## **MAC BUSINESS PARK SUBDIVISION**

APPLICATION NUMBER 8 DATE February 20, 2014  
APPLICANT MAC Business Park Subdivision (A private road Subdivision)  
REQUEST Subdivision

## DETAIL SITE PLAN

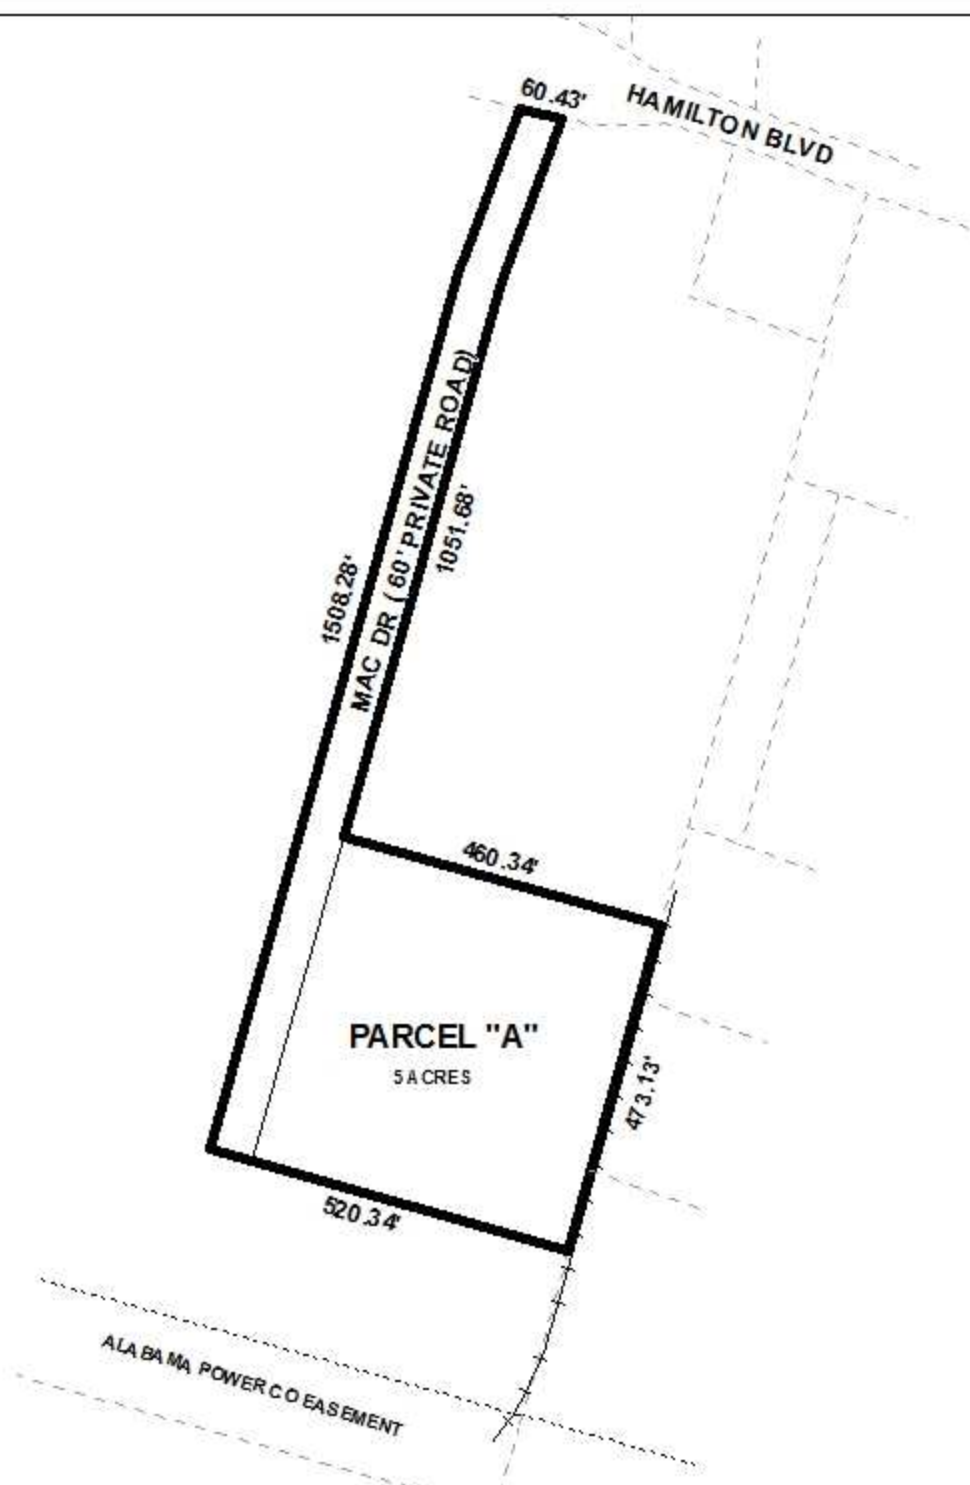
- A. Provide all of the required information on the SUBDIVISION PLAT (i.e. signature blocks, signatures, certification statements, written legal description, required notes, legend, scale, bearings and distances).

- B. Add a note to the SUBDIVISION PLAT stating that a Land Disturbance permit will be required for any land disturbing activity in accordance with the of the Storm Water Management and Flood Control Ordinance (Mobile City Code, Chapter 17 , Ordinance #65-007 & #65-045), latest edition.

- D. Dedication of the corner radius (25' minimum or as approved by the City Engineer and Traffic Engineer) at the west and east side of Mac Dr. where it connects to Hamilton Blvd.

- E. Dedication of a cul-de-sac or adequate turnaround (as approved by the City Engineer, Traffic Engineer, and Fire Dept.) at the south end of Mac Drive.

The site fronts Hamilton Boulevard which is shown as a major street on the Major Street Plan component of the Comprehensive Plan. The preliminary plat does not illustrate a right-of-way width; however, a 100' right-of-way is required. The plat should be revised to illustrate a 50' right-of-way from centerline of Hamilton Boulevard. The plat also depicts a private road named MAC Drive that will be utilized by the proposed parcel A, connecting the parcel to Hamilton Boulevard. The preliminary plat depicts MAC Drive with a 60' right-of-way thus no additional dedication would be required.

The 25-foot minimum building setback line, required in Section V.D.9., is not illustrated on the plat. Revisions should be made to depict the 25' minimum building setback line from the private street on the preliminary plat, and should be retained on the Final Plat, if approved.

The lot is not labeled in acres or square feet. Revisions should be made to depict the lot size in square feet and acres or a table should be furnished providing the same information.

It should also be pointed out that no justification was provided for the construction of a private street, nor was a turn-around indicated, within the development that complies with the requirements of the 2009 International Fire Code, as adopted by the City of Mobile. The plat should be revised to depict any additional right-of-way required for the turn-around, and the PUD site plan should also depict compliance.

- 1) submission of a 2-lot subdivision application to include both parcels ending in 3.001 and 1.001;
- 2) additional lot, labels and postage fees will be required for the additional lot;
- 3) depict additional land not included in subdivision as "Future Development";
- 4) labeling of lot sizes in square feet and acres or a table furnished providing the same information;
- 5) revise plat to depict right-of-way width for Hamilton Boulevard;
- 6) revise plat to illustrate a 50' right-of-way from centerline of Hamilton Boulevard;
- 7) submission of an application for Planned Unit Development for the proposed private street development by February 27, 2014;
- 8) revision to depict a 2009 International Fire Code compliant turn-around; and
- 9) justification for the construction of a private street.
